IN THE MATTER of a notice of requirement ("**NoR**") for a designation by KiwiRail Holdings Limited ("**KiwiRail**") for the Palmerston North Regional Freight Hub ("**Freight Hub**") under section 168 of the RMA

**STATEMENT OF EVIDENCE OF JOHN MCKENSEY
ON BEHALF OF KIWIRAIL HOLDINGS LIMITED**

LIGHTING

Figure 1. Proposed noise management barrier³

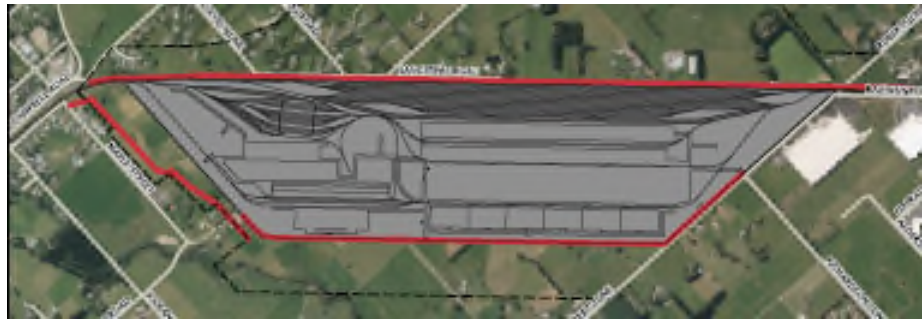
- 2.11 In response to a query regarding potential train headlight sweep to residents (in the First Section 92 response), it is considered that the proposed 5m high site perimeter noise barrier will effectively mitigate such effects. I have considered the degree of coverage afforded as indicated in Figure 1 and I agree with this opinion.

8.13 In regards to headlights from rail traffic once the Freight Hub is operational, I consider that the proposed noise walls will also suffice to ensure that locomotive headlights, approaching and operating within the Site, will be suitably screened to ensure that any added effects are negligible to the receiving environment.
